Wisconsin Department of Transportation

Proposal #03: 3020-00-70, WISC 2025358
Horicon - Kewaskum
CTH V to STH 175
STH 028
Dodge County

This is Addendum No. 02, which provides for the following:

CULVERT REPLACEMENT DETAIL

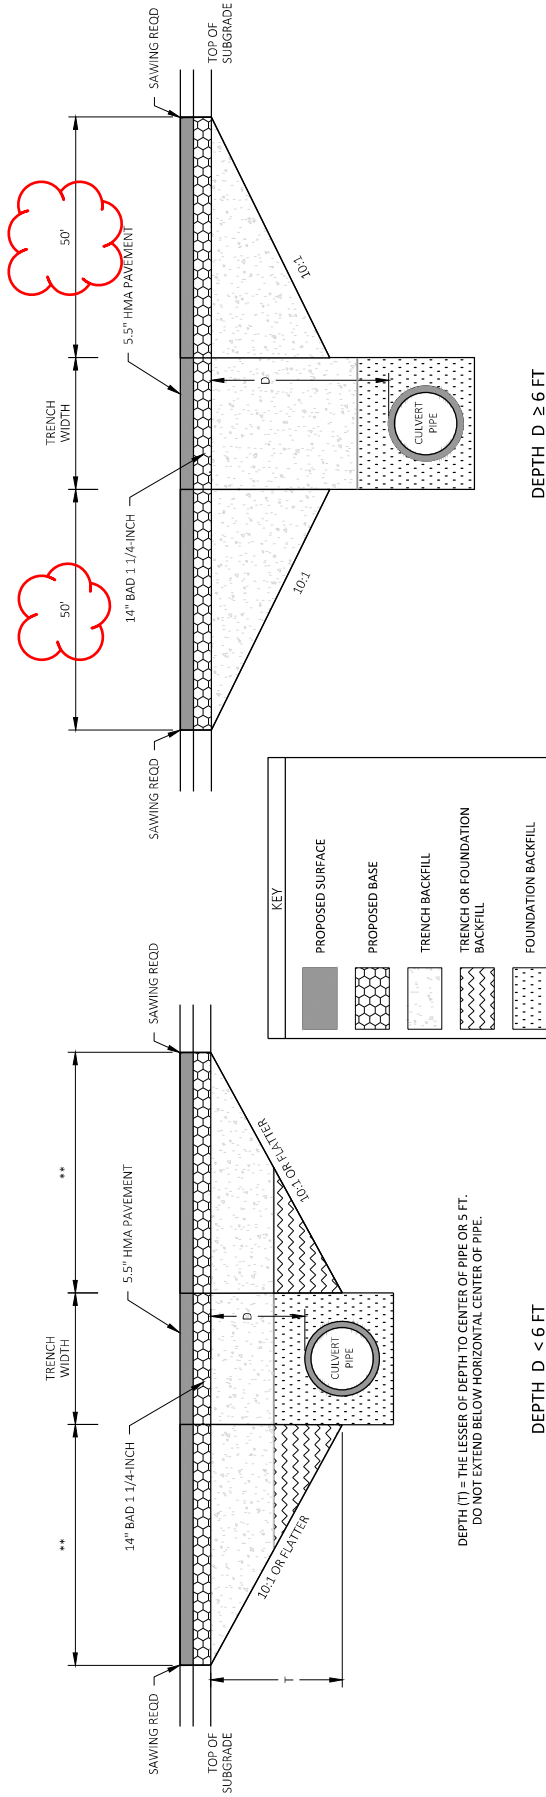
Revised Plan Sheets	
Plan Sheet	Plan Sheet Title (brief description of changes to sheet)
9	Construction Details – Added excavation quantities and removal limits to culvert replacement detail
43	Miscellaneous Quantities – Revised quantity of Asphaltic Surface to include full depth in culvert replacement areas

** DIMENSION DETERMINED BY ENGINEER IN FIELD
NOTE: EXCAVATION AND MATERIAL COSTS ARE INCIDENTAL TO CULVERT PIPE

ROUTE	STA (CL)	DEPTH D (FT)	PIPE DIA (IN)	EXCAVATION COMMON (CY)	TRENCH BACKFILL (CY)
STH 28	419+84	3.3'	30"	890	540
STH 28	503+44	6.6'	30"	1100	680
STH 28	578+07	12.6'	30"	1200	740
STH 28	616+62	2.2'	30"	620	340
